**PLANNING COMMISSION
SITE PLAN REVIEW SHEET**

CASE NUMBER: SPC-2024-0356C **PC COMMISSION DATE:** March 25, 2025

PROJECT NAME: ACCX - Convention Center C1

Site Plan Application – Master Comment Report

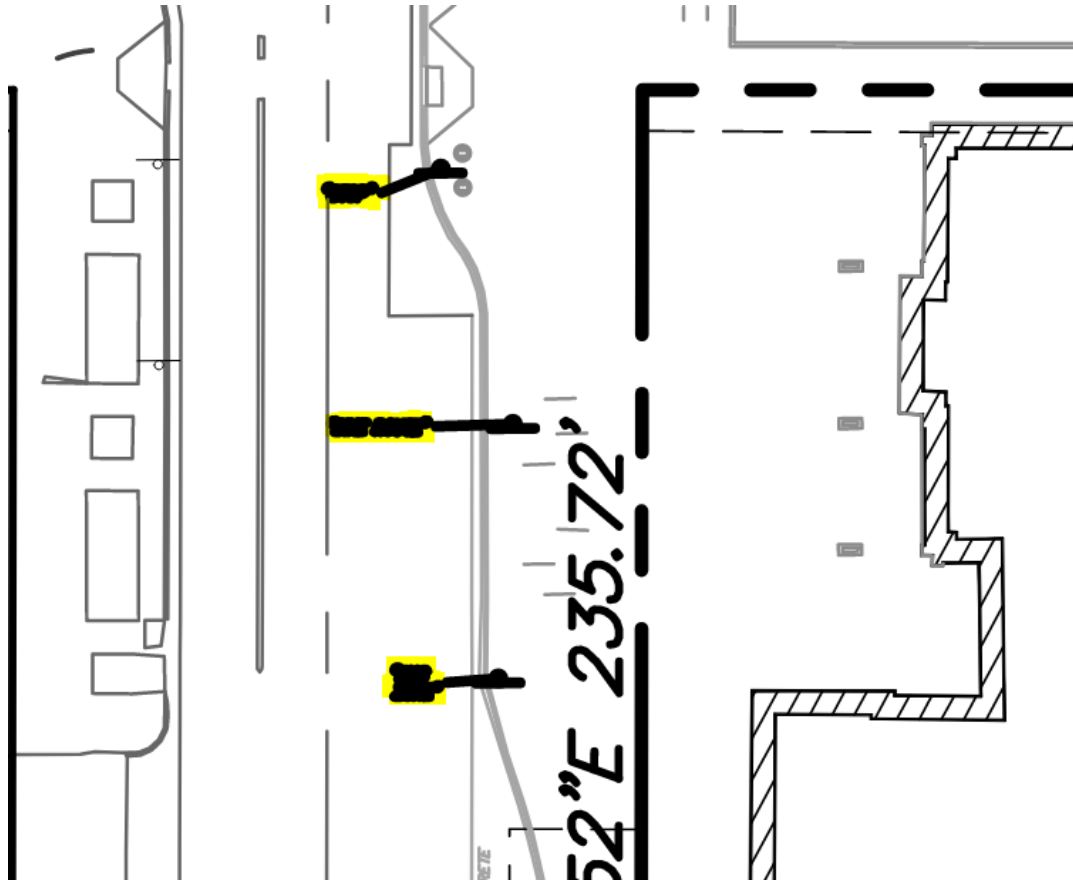
- U1: Illegible Text

The Overall Site Key Map, sheet 12, has added signage along Trinity St since the last update. The text associated with this signage is not legible. Please revise.

OVERALL SITE KEY MAP

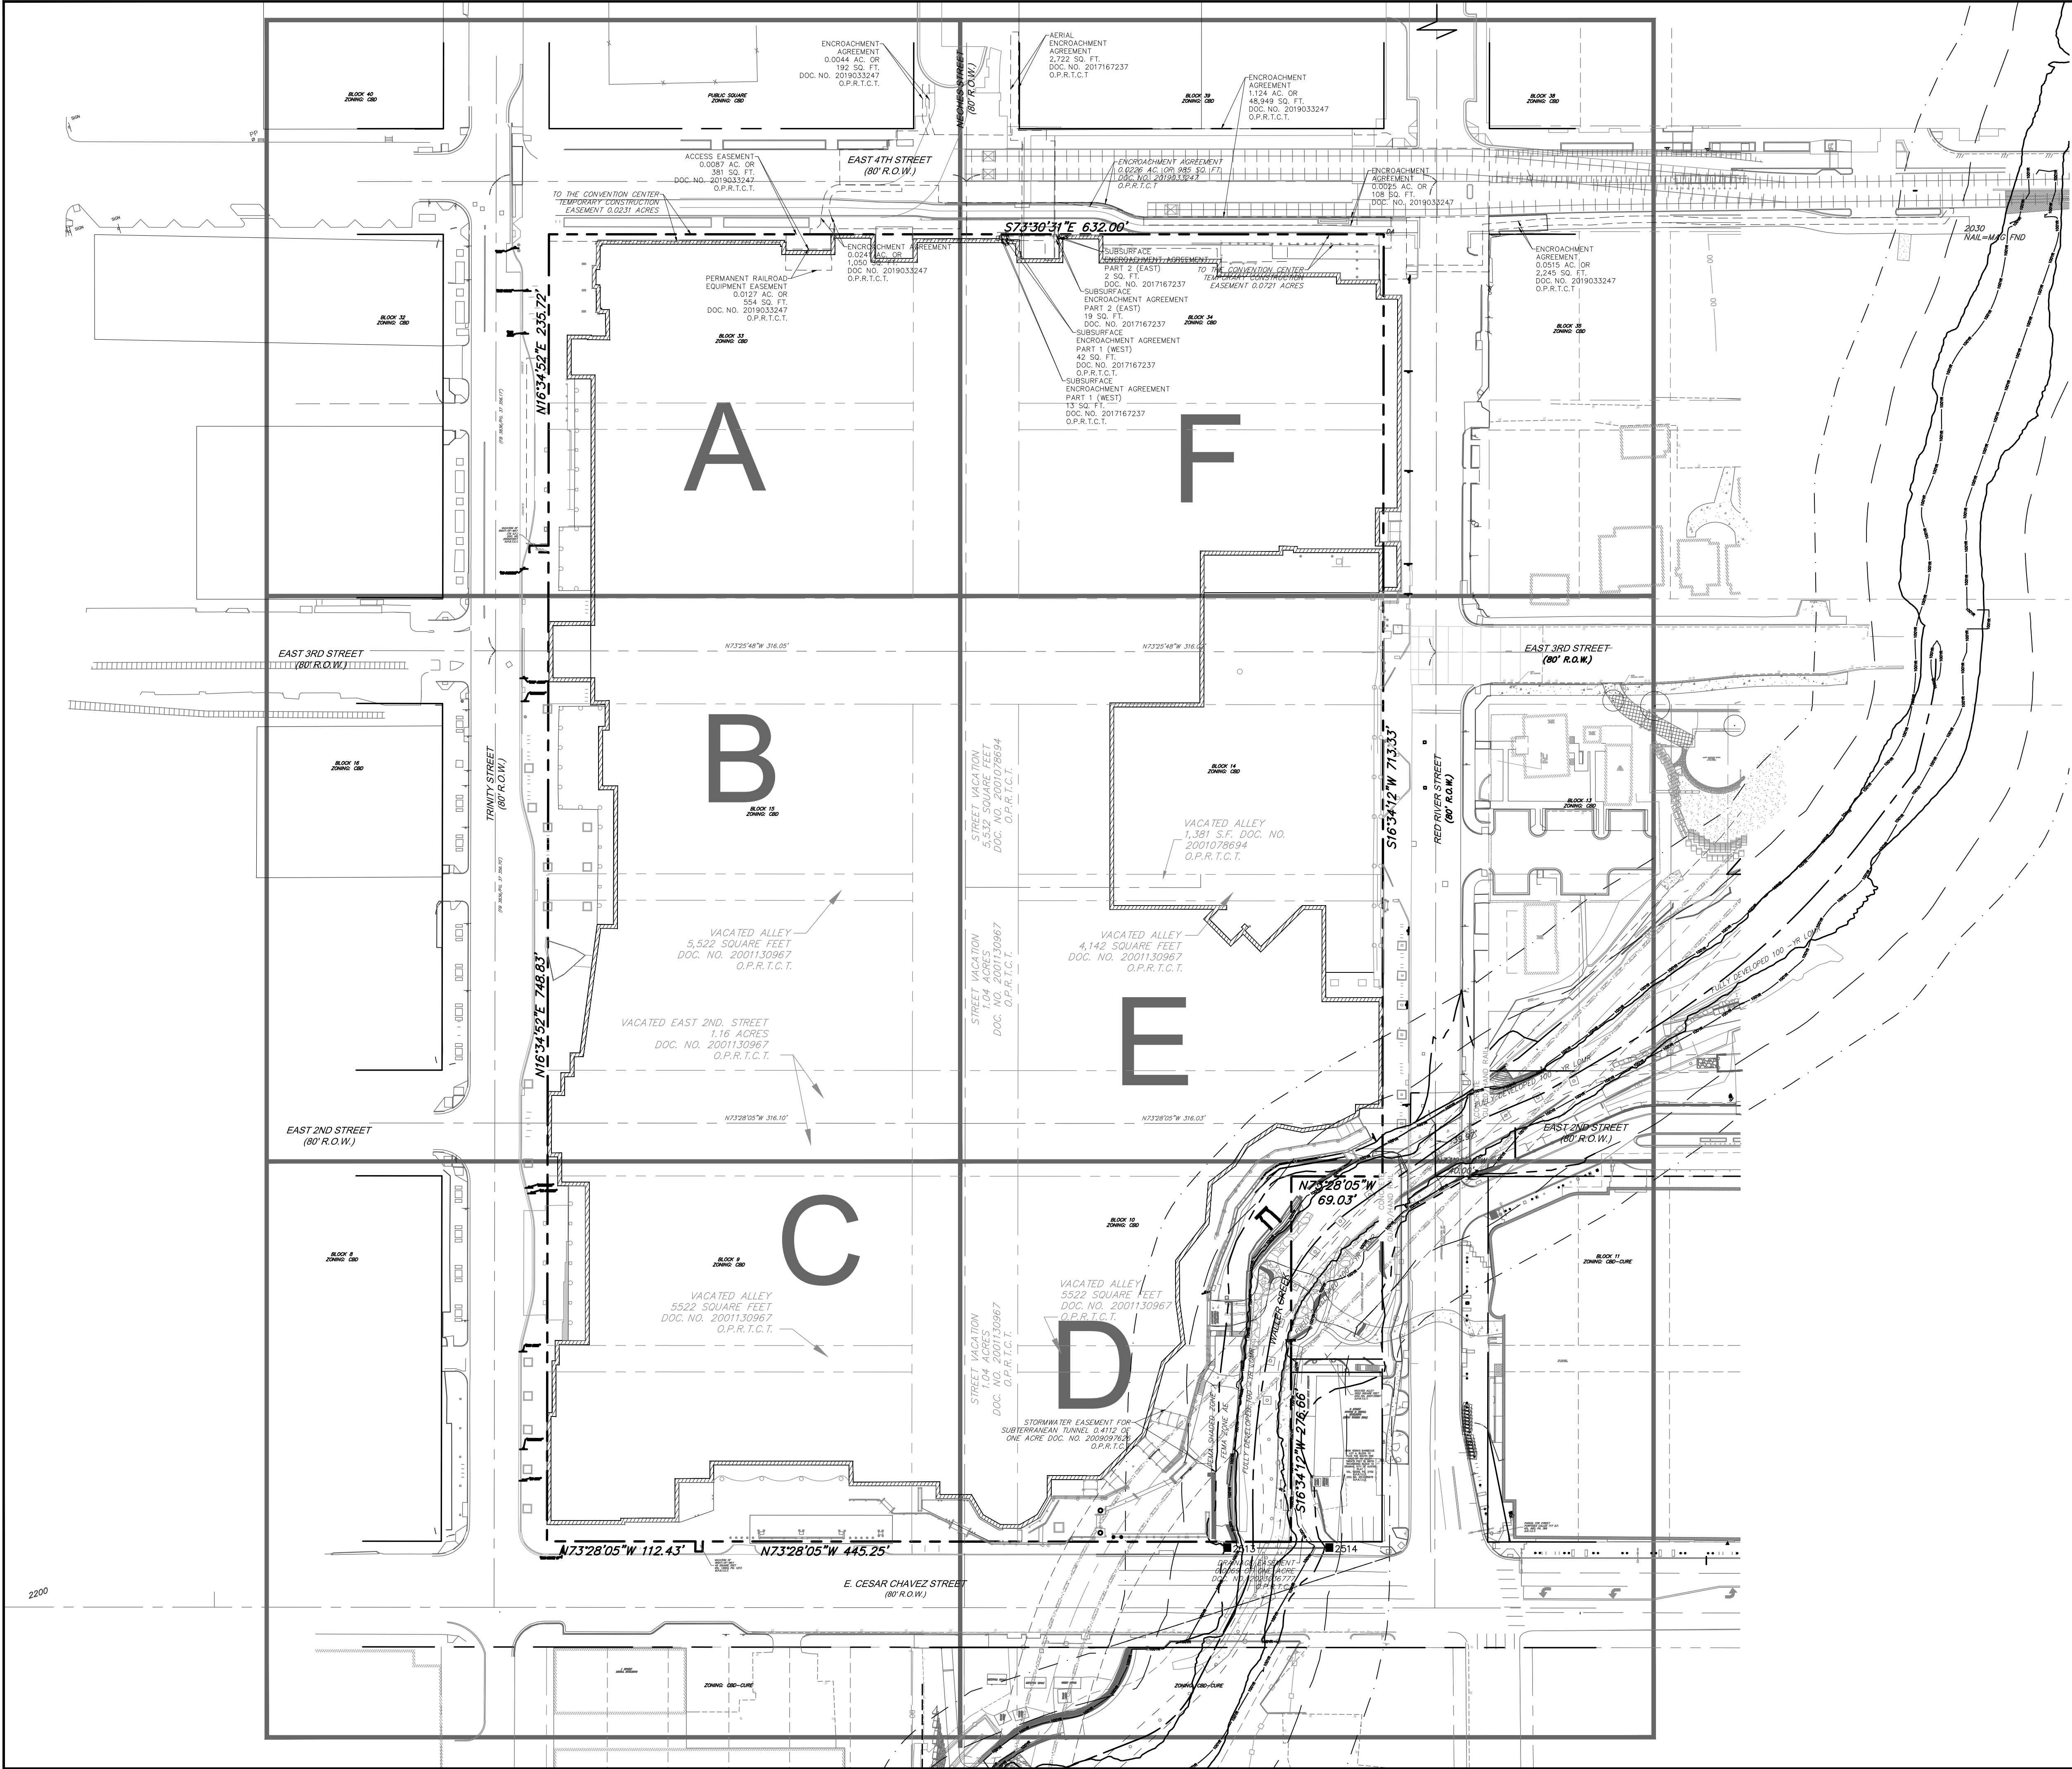
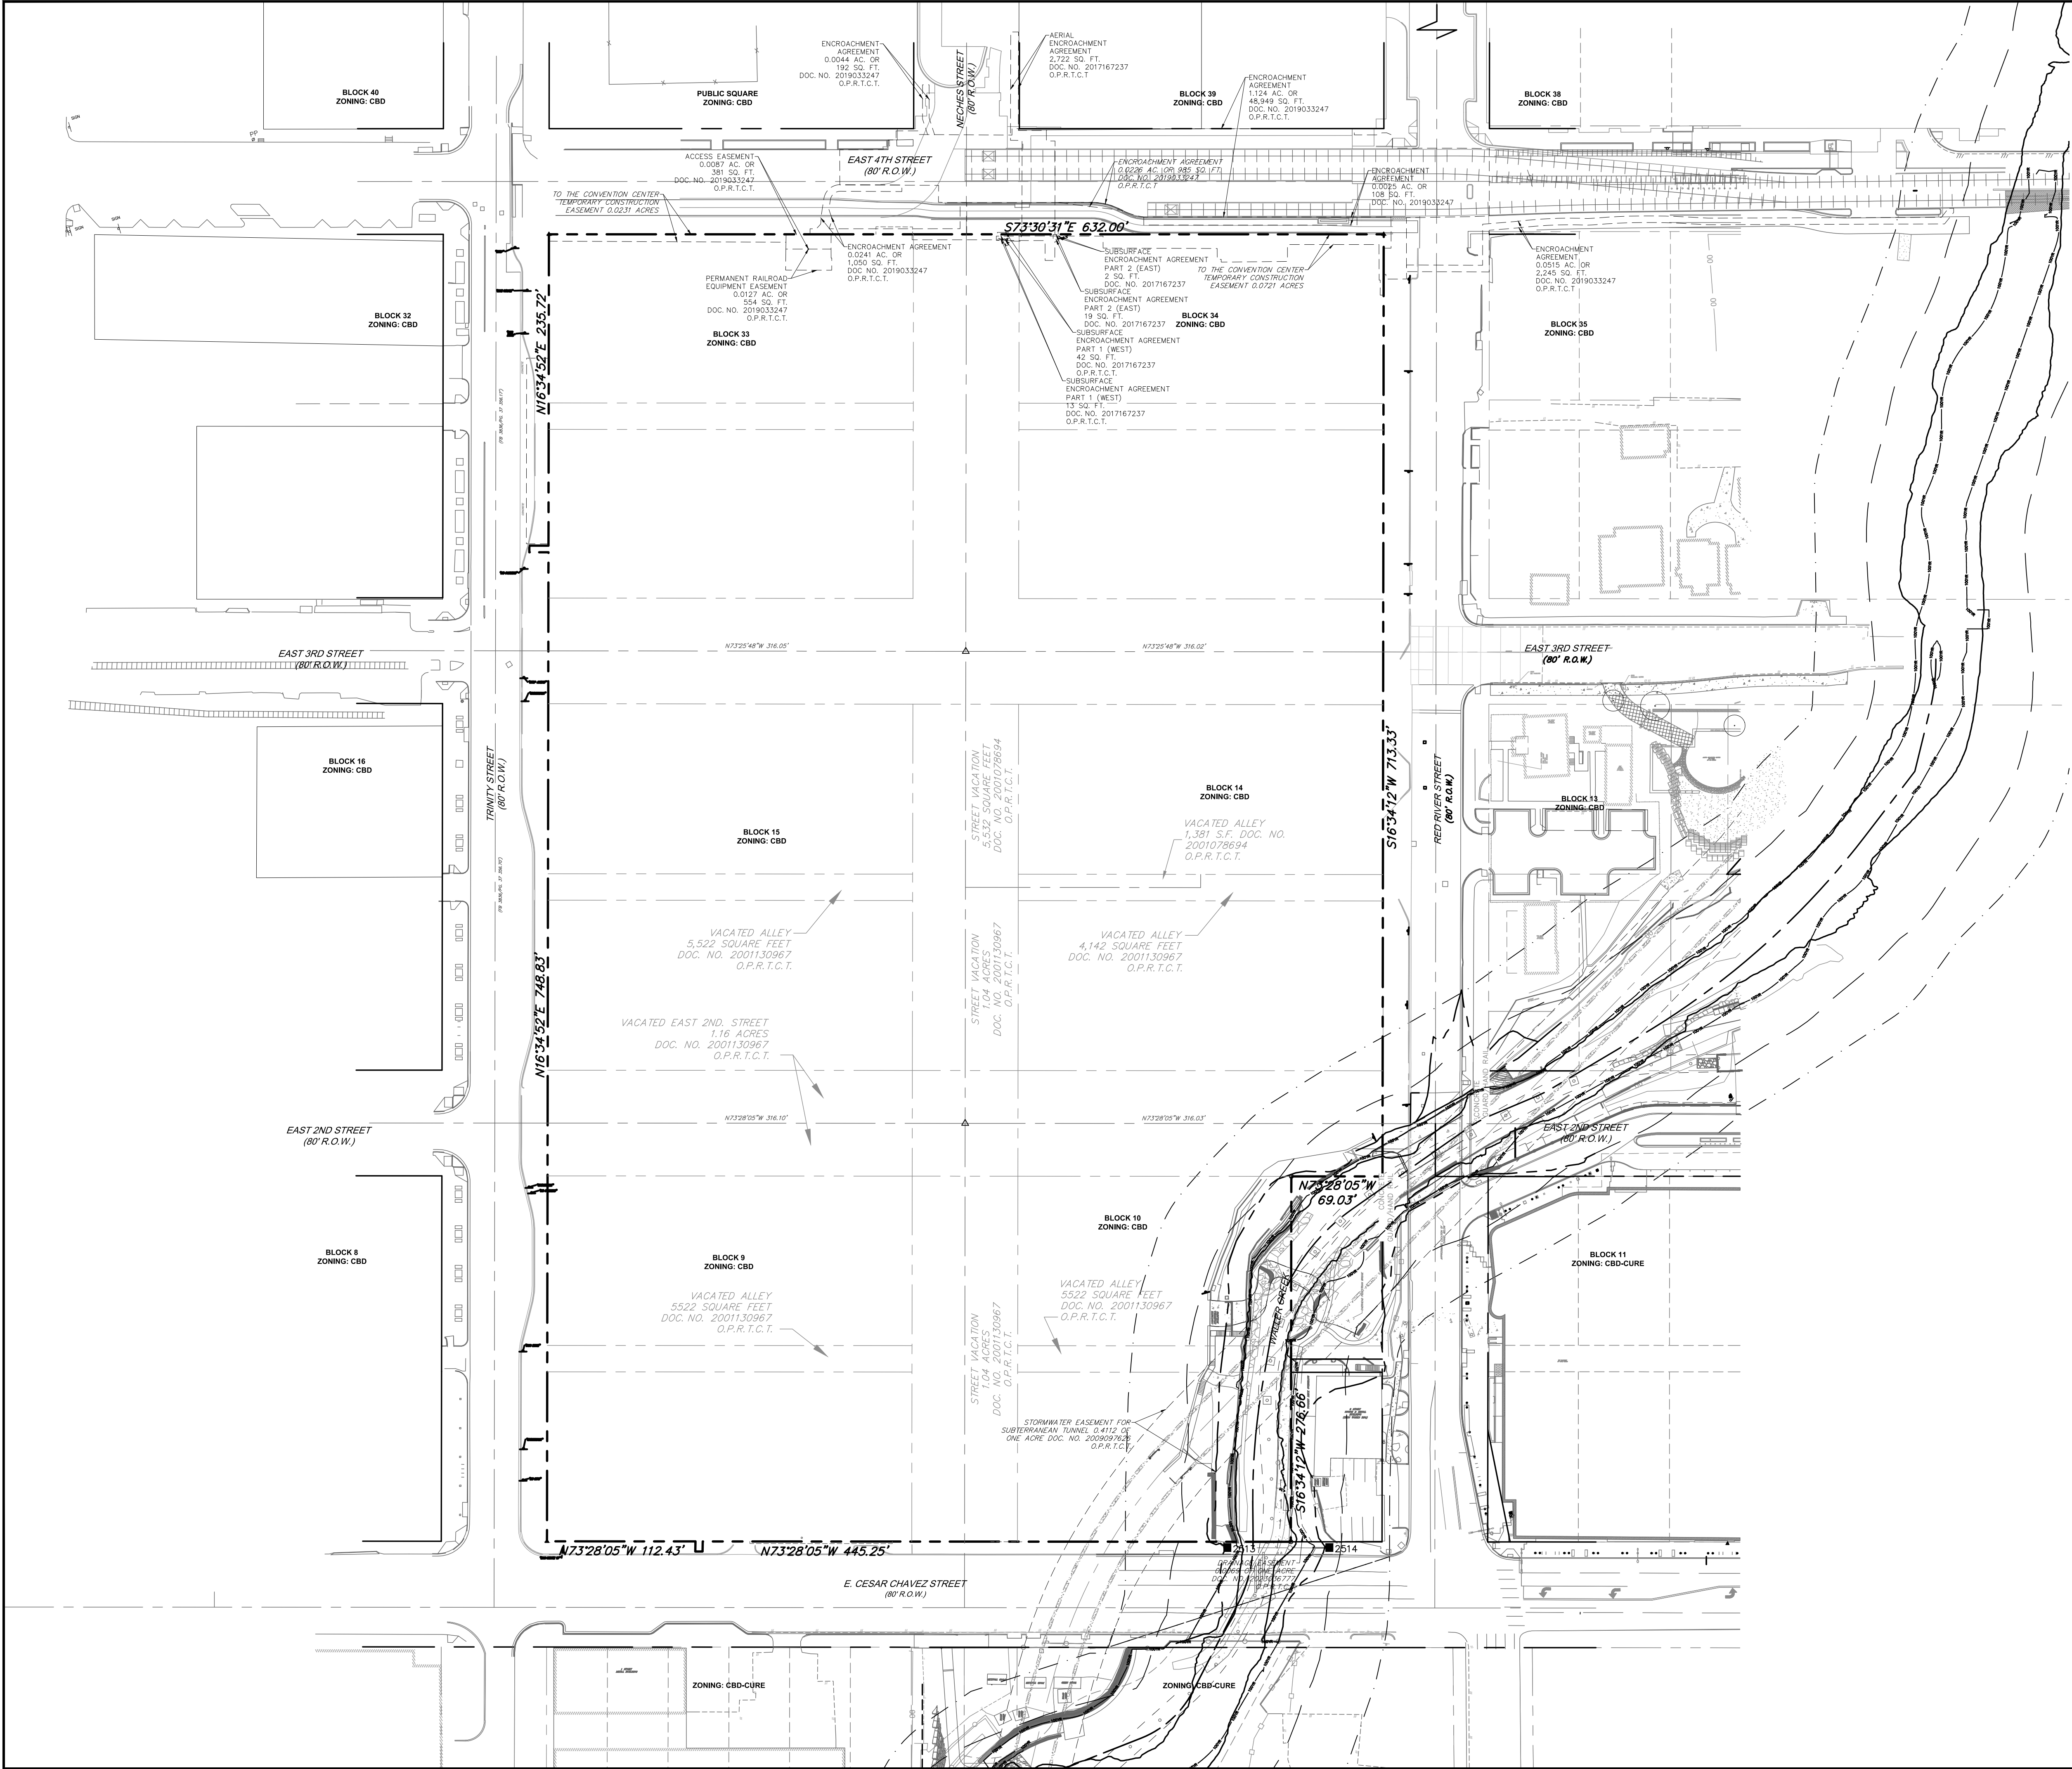
SP4 on sheet 12 provide a site data table with the following information: zoning (CBD, use (convention center), existing and proposed IC, LOC or site area.
